# **Process Sheet**

Dart Helicopters Services Customer

: D3763041 D3763 REVB

: END FITTING ASS'Y

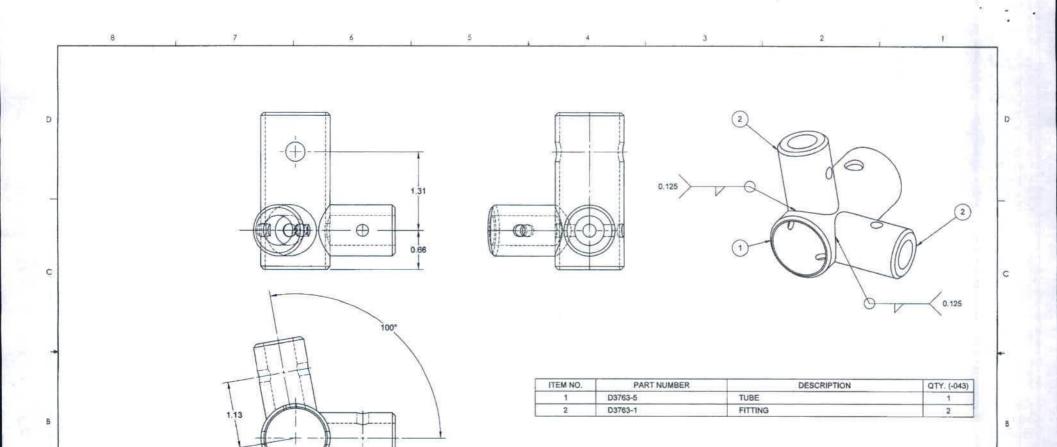
Part No	1734	763-041 PAR#: 84-011/043/044 412-769-043/044	_ Fault Ca	ategory: hgo FAB N		O DQA:		08.08-21
NCR: 4			ORK OR	DER NON-CONFORMANO	E (NCR)		2	-
		Description of NC		Corrective Action Section B		Varification		
DATE	STEP	Section A	Initial Chief Eng	Action Description Chief Eng	Sign & Date	Verification Section C	Approval Chief Eng	Approval QC Inspector
08-08-08	4.0	K.C. Employee did not	Posiuge	- atil 2 parts good.  Replace at 8 a the -2-split was -scrap & destroy the	OR:08-04	108-08-08	Joseph	000 000
		weld as per chug.		tield/plug holes a redail	/			7
